Access Compliance Report

Public Rights-of-Way

Intersection ID: 10017651	Main Street: GRIER_SPRINGS_LN	Cross Street: N/A	Location:	N
ADA ID: 2583CCA413BA	Ramp Type: BlendTrans1	Initial Pass/Fail: Fail	Overall Compliance: No	Severity Score: 35

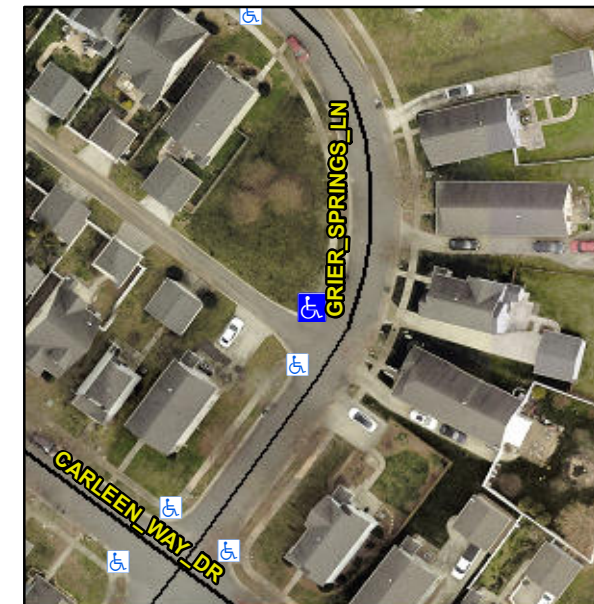
NO LT SW

Not Found, R304.5.1

Remove & Replace Curb Ramp With Two New Directional Ramps or Equivalent.
